TECHNICAL INFORMATION

58776

- Subject** ▶ Changes on Gear Housing Complete and Screw
- For Models** ▶ 9040L, 9047, 9047L, 9047S, 9049, 9049S, 9057, 9057S, 9059, 9059S
- Country** ▶ All countries
- Description** ▶ As illustrated below, Gear Housing Complete and Screw have been changed for quick repair.

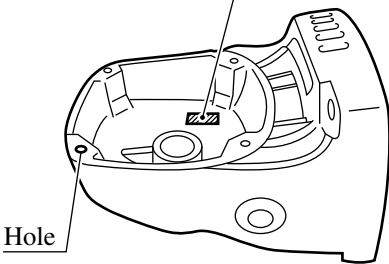
► Current	► New
Gear Housing Complete	<p>Inscription of "3168530"</p>  <p>Hole</p> <p>(Part No.159907-8)</p>	<p>Inscription of "3173151"</p>  <p>Treatment for Screw M5</p> <p>(Part No.151859-9)</p>
Screw (4pcs.)	 <p>Tapping Screw (Part No.266027-2)</p>	 <p>Pan Head Screw w/spring washer (Part No.911226-8)</p>

Item No.	Current part		Q'ty	I/C	New part		Q'ty	Note
All models: 016	Gear Housing Complete 159907-8		1	No	Gear Housing Complete 151859-9		1	Interchangeable as a set
All models except 9040L: 033 9040L : 031	Tapping Screw Bind CT 5x16 266027-2		4	No	Pan Head Screw M5x18 911226-8		4
